Global Change Notification (GCN)

Product Family	SATA	10670203
		GCN Number
Series	47080	February 04, 2015
		Date Issued
Reason For Change	Change Construction Or Material	
Change Description	The purpose of this letter is to inform you that we plan to change PA6T to LCP to avoid HSG blister quality issue, We have done reliability tests and verified no impact, The target date of implementation is 2015/4/1, The parts list as enclosed.

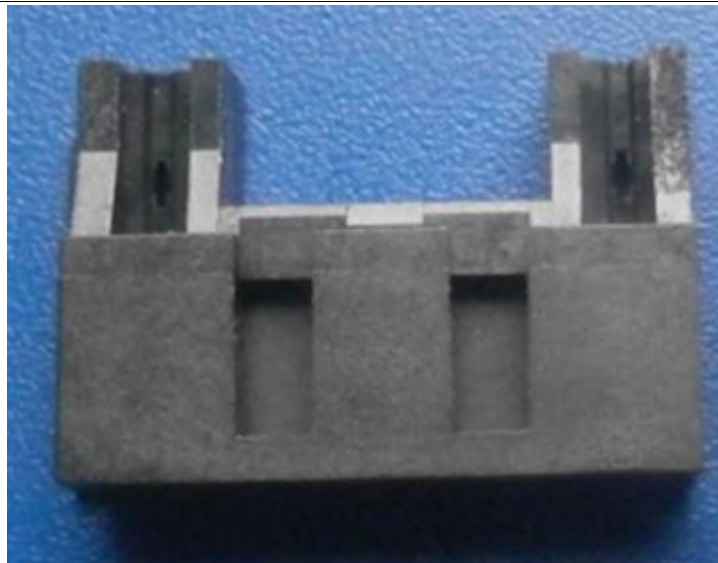
before

after
